IDAP REPORT

Property:	101 The Boulevard STRATHFIELD Lot 1 DP 915018 DA2021/249
Proposal:	Partial demolition of the rear building, alterations and additions to the rear of the existing dwelling house, attached carport and associated works.
Applicant:	Bykoo Land Pty Ltd
Owner:	F & ASL Tan
Date of lodgement:	24 September 2021
Notification period:	7 October 2021 to 21 October 2021
Submissions received:	Nil
Assessment officer:	J W Brown
Estimated cost of works:	\$1,111,000.00
Zoning:	R2-Low Density Residential - SLEP 2012
Heritage:	Heritage Conservation Area C17 - Woodward Avenue Conservation Area (HCA)
Flood affected:	Yes
RECOMMENDATION OF OFFICER:	APPROVAL

Figure 3: Proposed upper ground floor plan

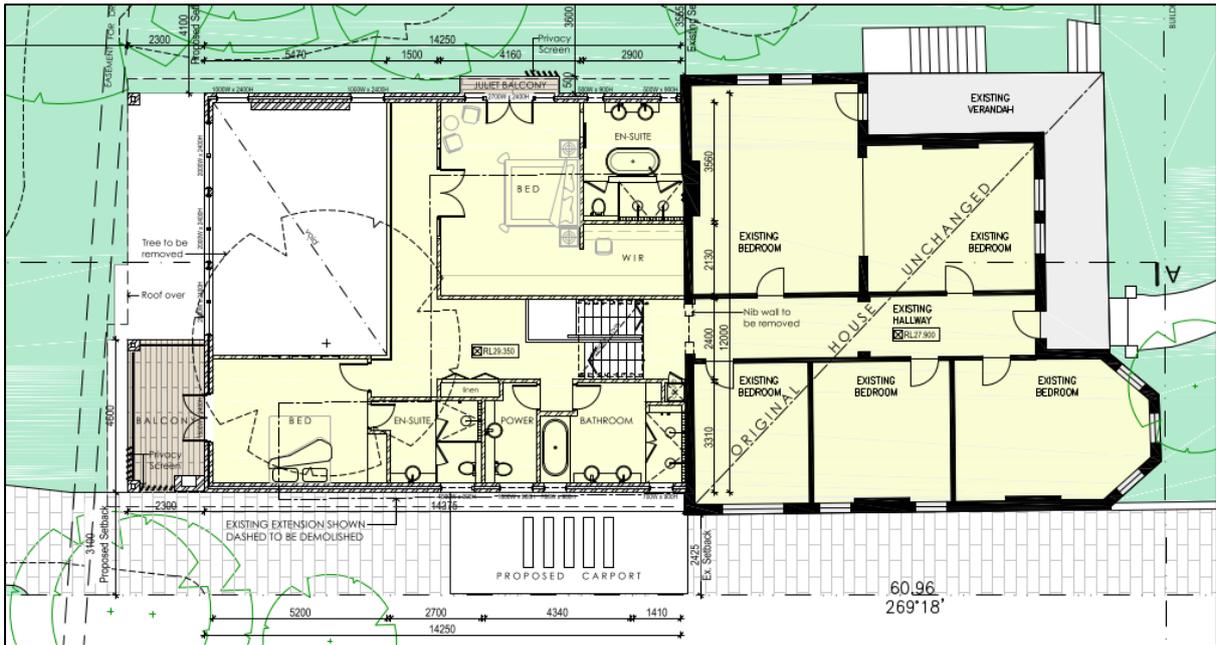
The side Juliet balcony will be required to be removed from the proposal, as it is unnecessary, creates the potential for overlooking, and is prohibited on side boundaries in the SCDPC 2005. The rear-facing balcony size is acceptable as privacy screening has been provided to lessen the impact of overlooking onto the southern neighbour.

Juliet Balcony	The Juliet Balcony on the northern elevation must be removed and does not form part of this consent.
----------------	--

Figure 12: Rear vegetable garden to be grassed

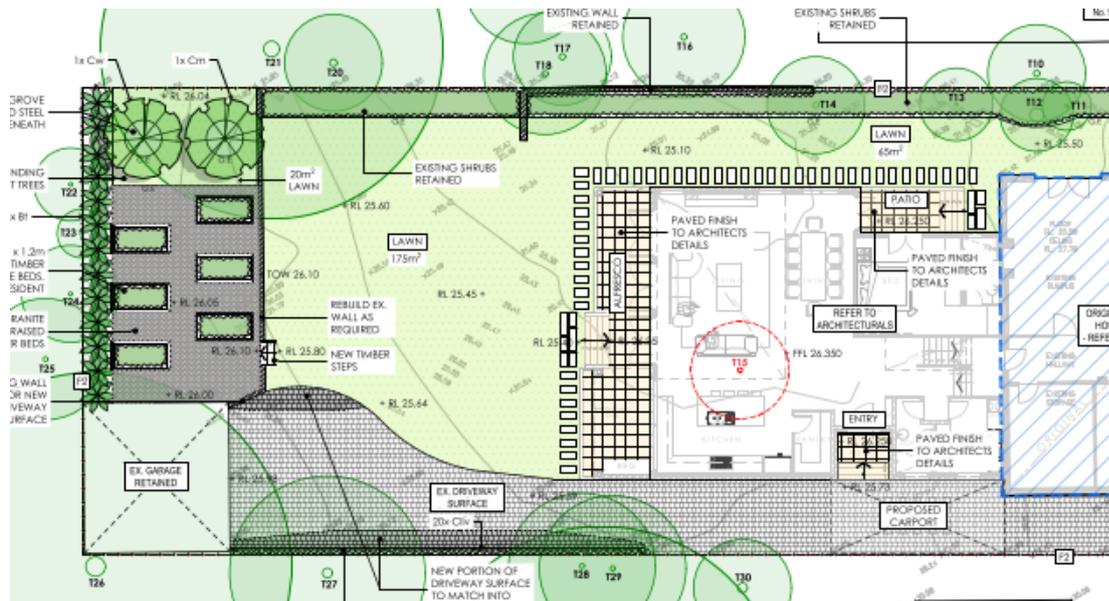
The proposed landscape area is 39.5% and is non-compliant with the SCDCP. The SCDCP requires at least 45% of the lot to be landscaped. To improve this, a condition will be added that the rear vegetable garden be grassed and stepping-stones be used instead of the granite surface proposed around the planter beds. This will add at least an extra 40m² landscaping to the property and minimise the hard surfaces in the rear of the yard. Parts of the existing driveway could not be removed as it provides a turning circle for vehicles to ingress and egress in a forward direction. With this change in the design, the non-compliance is acceptable in these circumstances.

Landscaping	The landscape plan must be amended with the rear vegetable garden to be grassed and the use of stepping-stones instead the granite surface proposed around the planter beds.
Carport	The attached carport must be wholly within 101 The Boulevard, Strathfield, and must meet the requirements at BCA.
